PROJECT STATE OF VERMONT - AGENCY OF TRANSPORTATION
BRIDGE No 31 - RICHMOND, VERMONT

BRIDGE # HIGHWAY #1 OVER WINOOSKI RIVER
CHORD MEMBER DETAILS

T BUCK CONSTRUCTION DWG NO 09-113 - 02

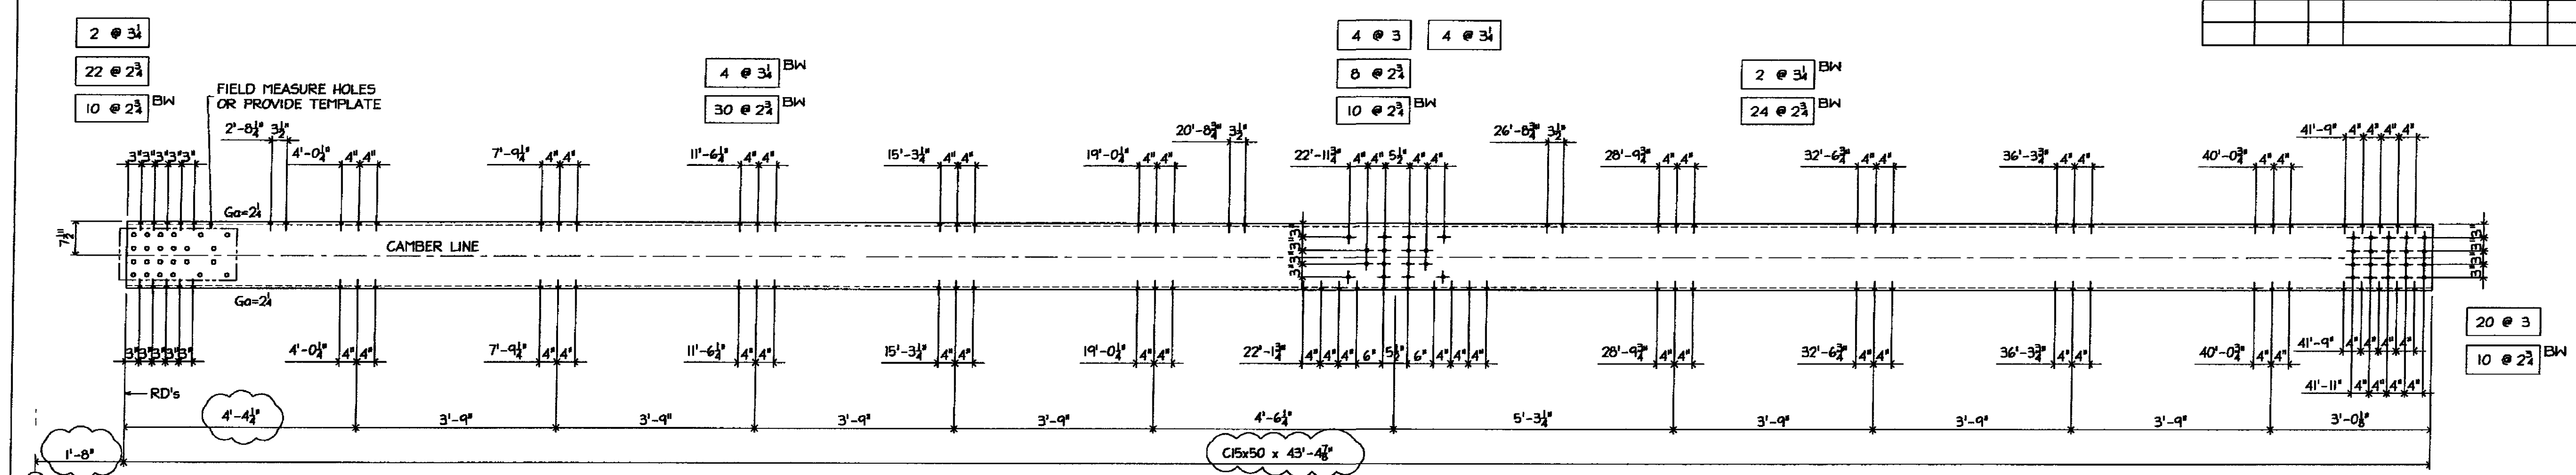
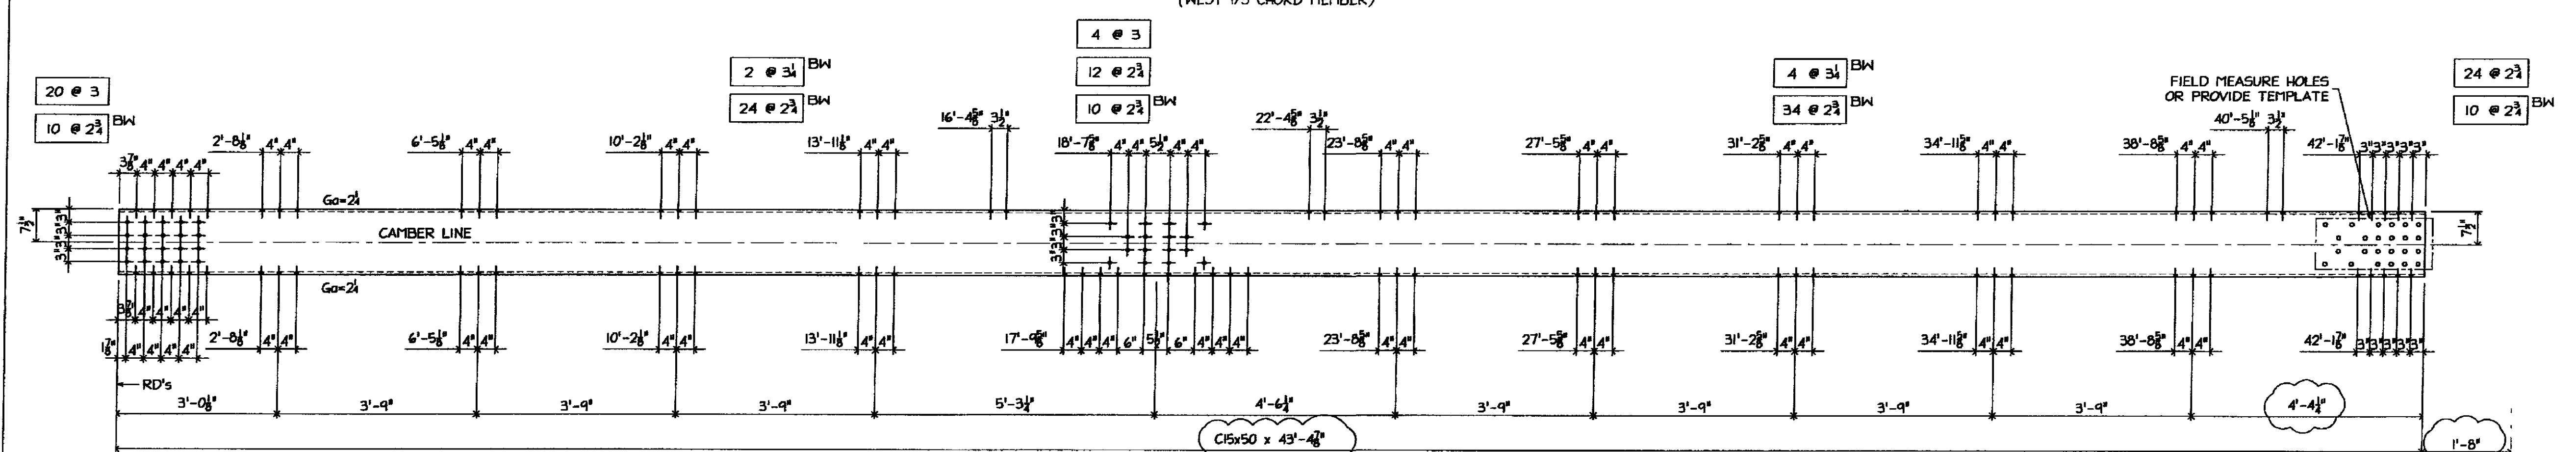
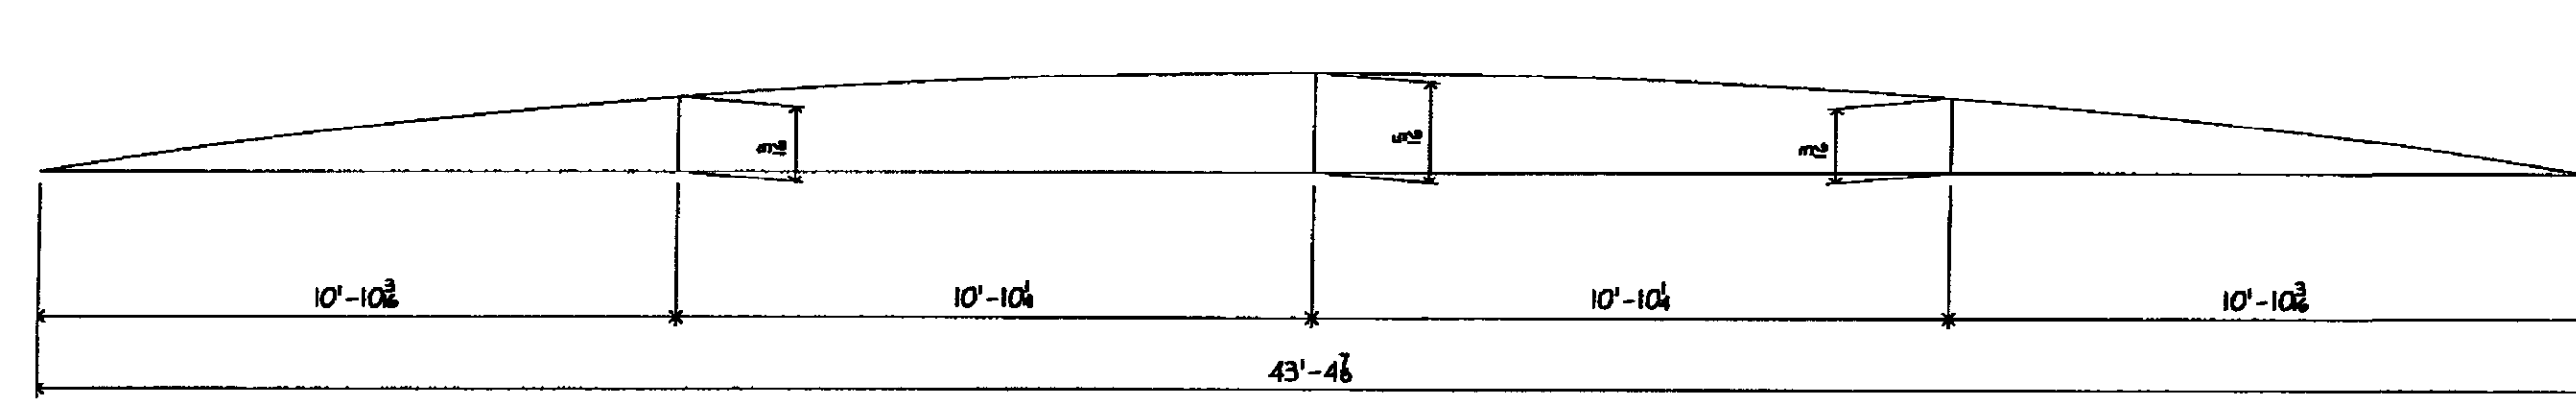
3/11/09 PER APPL COMMENTS DATED 3/06/09
